ARPANSA Regulatory Assessment of the Replacement Reactor Construction Application

28 August 2001- Reactive Review Questions and Issues

PSAR Appendix A PSA

Figure PSA.60.1: Case analysed for the partial blockage of a cooling channel

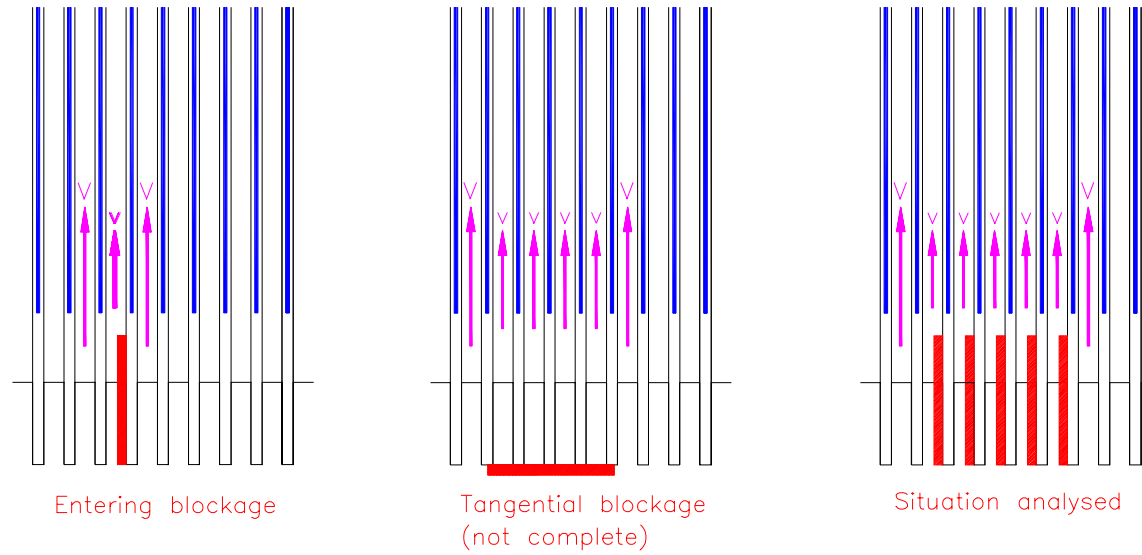
Response: See response to Question PSA.22.
PSA.60.	3.4.9 Fuel Channel Blockage-B5	This event does not lead to core damage so not considered in the PSA.	What is the potential for some fuel plate damage, depending on the blockage and subsequent behaviour of the fuel. Have other mechanisms for partial fuel damage also been considered, such as flow induced vibration and mechanical damage during fuel loading.
			<p>Response: The analysis of channel blockage has been done for two different cases with the following assumptions:</p> <p>1) The whole length of a fuel channel is blocked, with a piece that enters 2.5 cm into the channel. This case is worse than the tangential blockage of the channels, with no intrusion of the blocking object into the channel, because it leads to lower coolant velocities in the blocked channel (See Figure in Appendix PSA.1.</p> <p>2) A single channel is completely blocked. The heat removed by counter current flooding mechanism is conservatively neglected, then the two adjacent channels receive a heat flux which is 50 % larger than the normal one. The local heat flux at the plate in contact with the blocked channel doubles with respect to the normal heat flux</p> <p>The results for case 1 (See Appendix PSA.1) show that for blockages of as much as half the flow area of the channels,</p>

Question reference	Section number and name	Topic	ARPANSA Comment, Issue and/or Question and ANSTO's Response
			<p>the margins to critical phenomena are above the safety limit. ONB is attained for blockages greater than 30 % of flow area. The fuel plate wall temperature is well below design limits (blistering temperature is 450°C) for all cases.</p> <p>The results for Case 2 (Appendix PSA.1) show that the maximum plate wall temperature in contact with the blocked channel reaches a value of 252°C, which is also well below design limits. The channels adjacent to the blocked one attain ONB conditions.</p> <p>The core is designed to have a velocity below the safety limit of 2/3 of the critical velocity (see Chapter 5, Table 5.8/4 of the PSAR). The design of the fuel assembly is being hydraulically tested in the detail engineering phase.</p> <p>Therefore, there is no physical mechanism that can provide a flow large enough to trigger flow induced vibration damage. Mechanical damage during fuel loading is discussed in Chapter 16, Section 16.13 of the PSAR.</p>
